The following error was found in the EX ROVR Instruction Manual. We apologize for the error and correct it. Please check back for additional details.

List of Corrections

No.32 Additional Functions

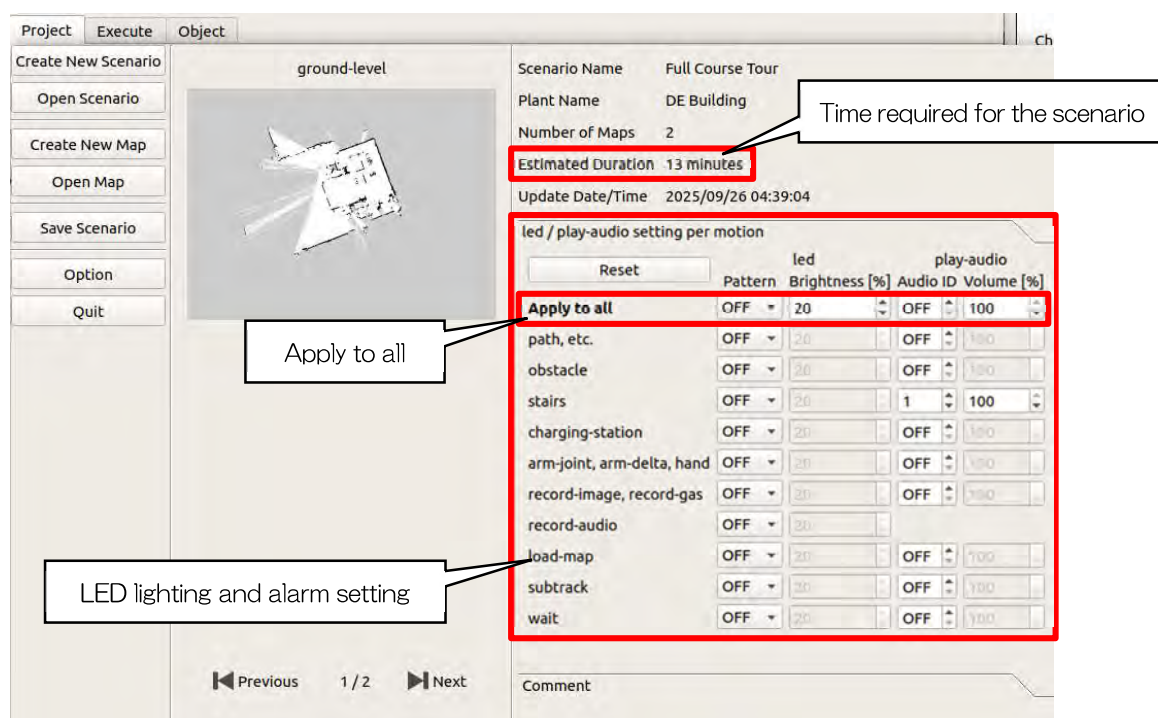
- Scenario time calculation function

The time required to execute the scenario displayed in the Scenario tab is calculated and displayed.

- LED lighting function and alarm function during scenario execution

During scenario execution, the LED at the end of the manipulator can be lit and an alarm sound can be emitted from the speaker. Settings can also be made for each individual motion. The LED pattern and sound source can be selected from a selection of led motion and play-audio motion.

No.33 Additional Functions

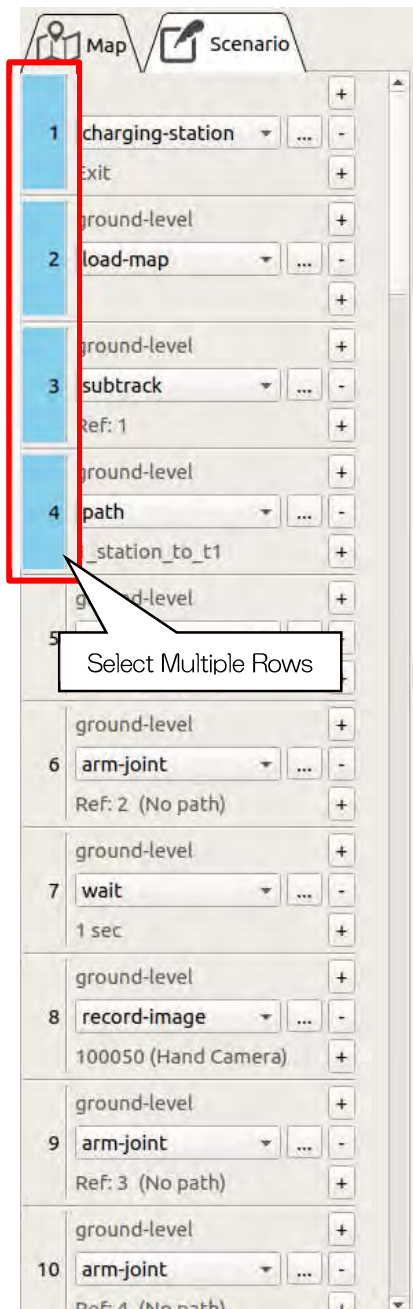
Shift-click to select multiple motions.

Then, click [Execute Selected Line(s)] to execute the selected range.

No.34 Additional Functions

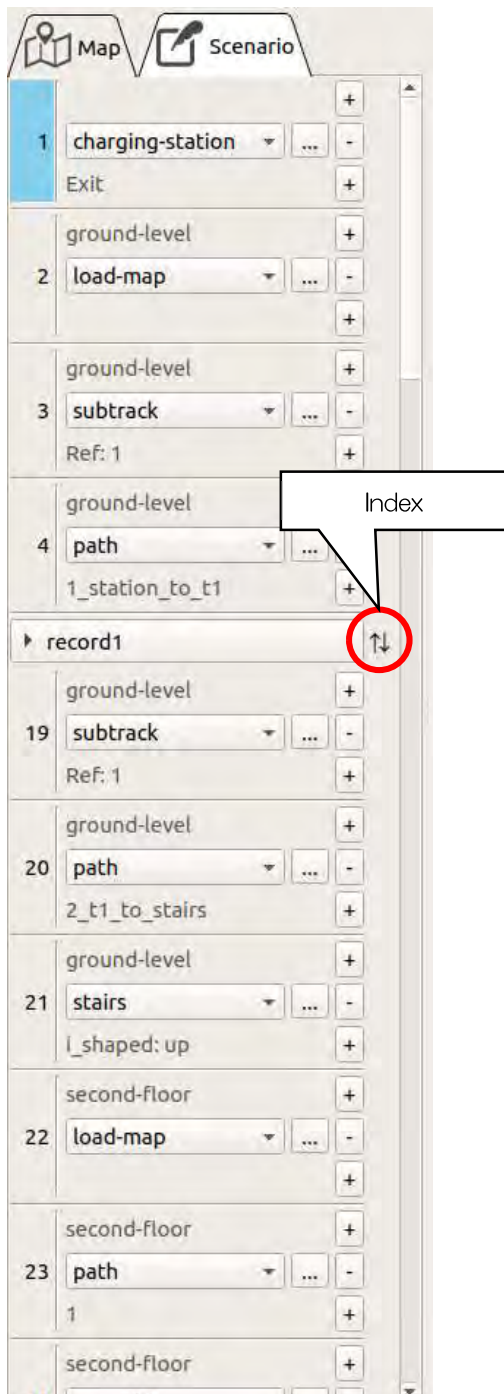
Drag the group index with the mouse to move its position.

No.35 Additional Functions

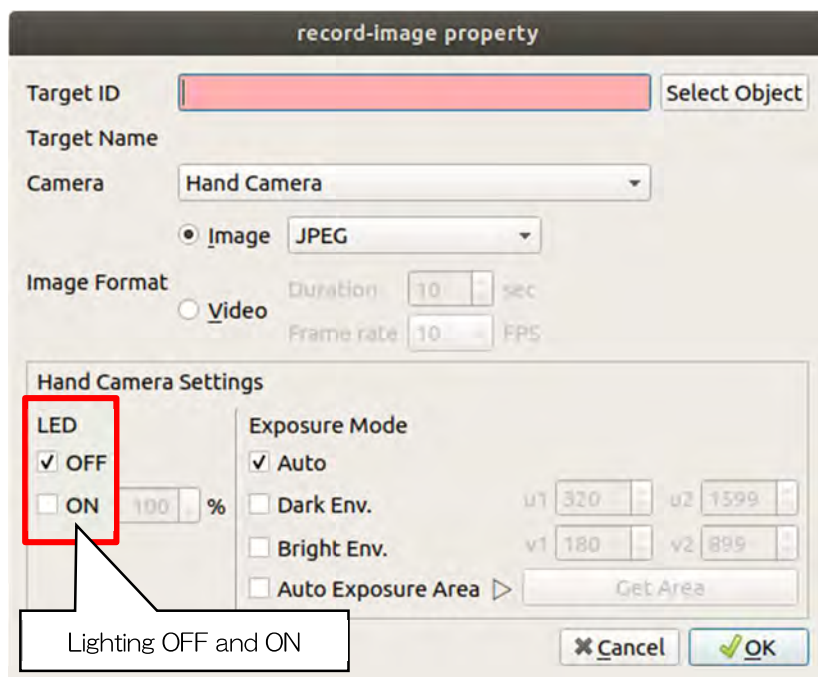
After moving, change ASCENT to the desired orientation, and then click [Acquire current] for [Final Heading]. [Final Heading] generates rotate-to-heading motion.

When [Final Heading] is specified, ASCENT will rotate to the specified orientation and stop after moving to the destination during scenario execution.

No.36 Additional Functions

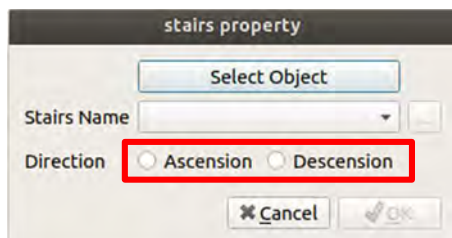
It is possible to capture images in both lighting OFF and ON conditions within a single motion. When both OFF and ON are checked, images will be captured in both lighting OFF and ON conditions.

No.39 Additional Functions

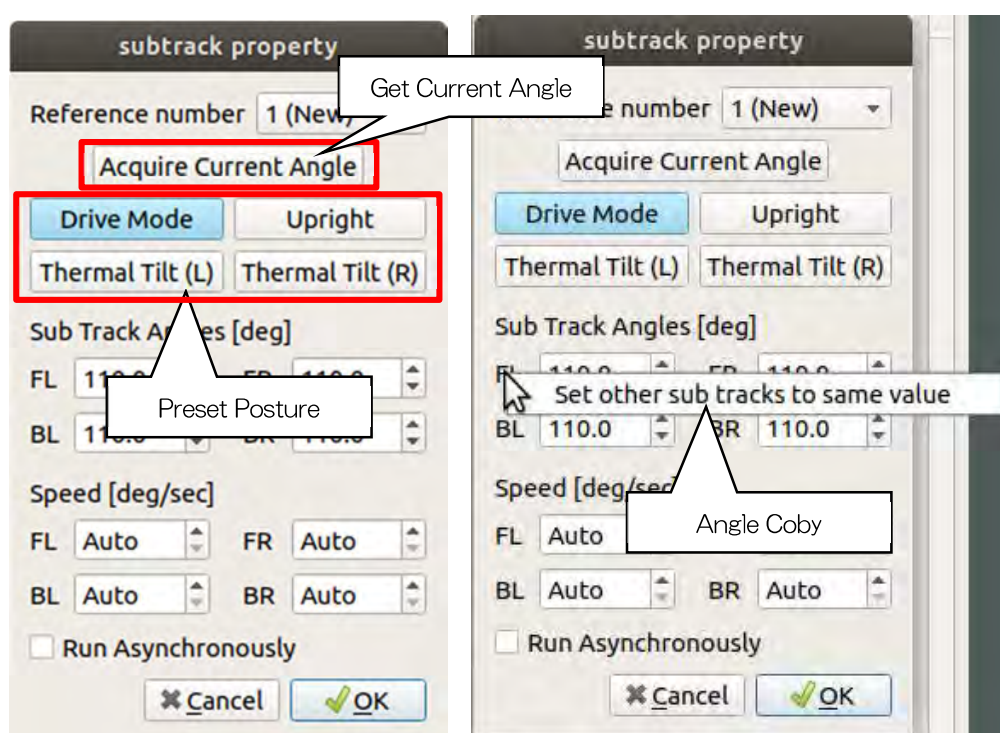
In the “subtrack” motion, selecting [Drive Mode], [Upright], [Thermal Tilt (L)], or [Thermal Tilt (R)] allows you to configure the angle of the preset posture.

To set the sub track angle, click [Acquire Current Angle] to set it to the current angle. When you right-click the label of the target angle (e.g., FL, FR, etc.), a menu appears that allows you to copy the value to another angle.

No.40 Additional Functions

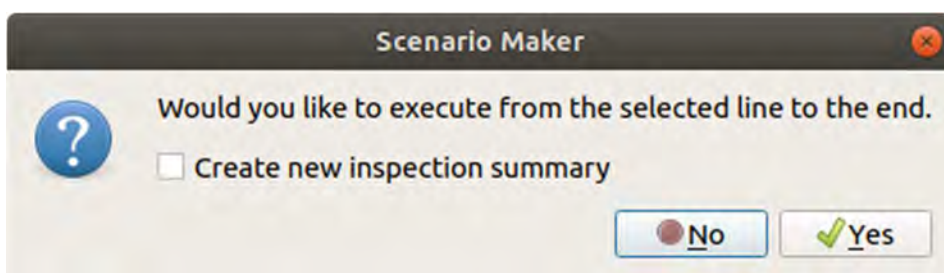
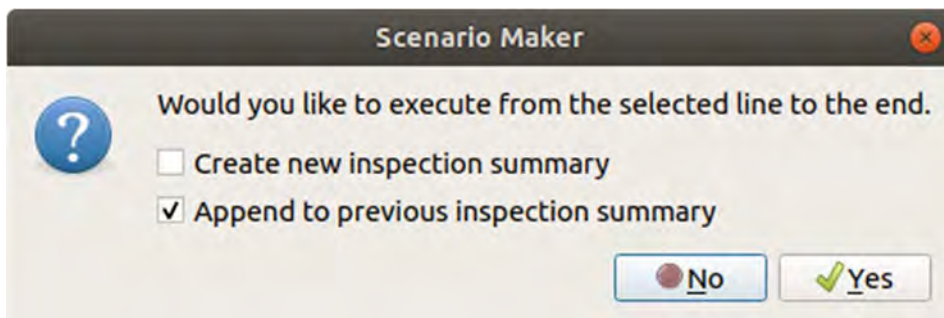
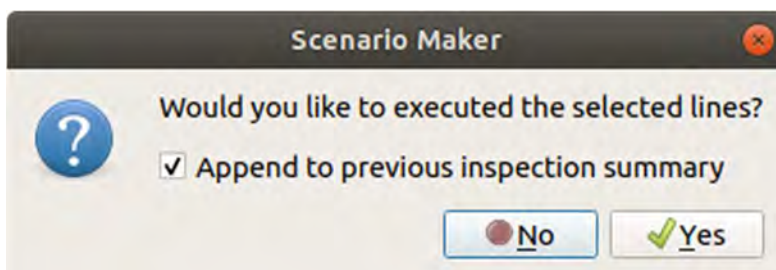
Click [Execute to End] button to create a inspection summary.

After performing [Execute to End], if the checkbox is selected, a new inspection summary will be created.

If you pause once during inspection summary creation, you can continue appending from where you left off by using [Execute to End].

You can append from the same state by using [Execute Selected Line(s)].

■ **Unable to Land Smoothly on the Landing After Ascending Stairs**

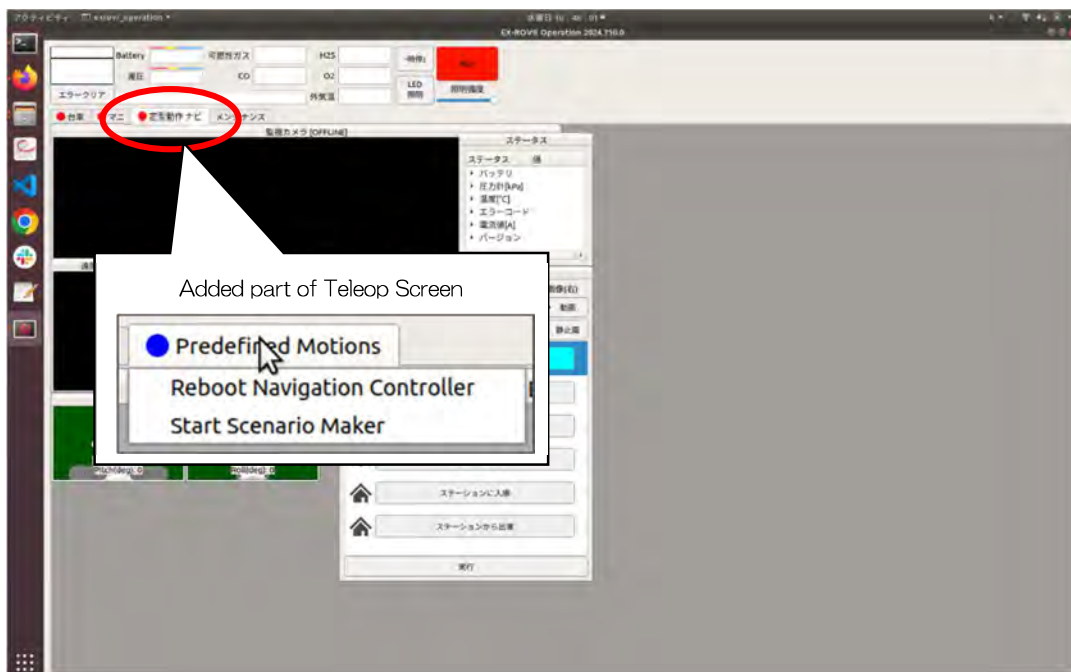
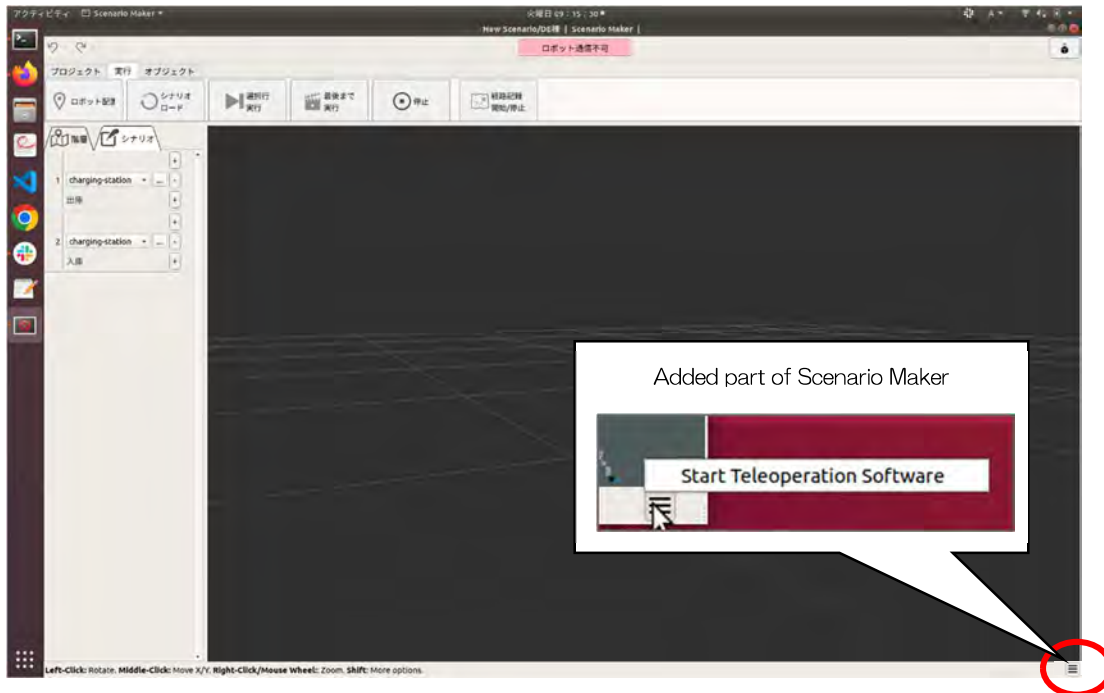
The reflector may not be detected correctly.

Please readjust the position of the reflector. Attaching reflectors on both sides of the stairs is also effective. Note that even if detection failures occur, operation may continue as long as safe patrol can be resumed.

[Previously, Navcon error 160 occurred, causing the system to stop at the stair landing. This measure is implemented to allow patrol to continue.]
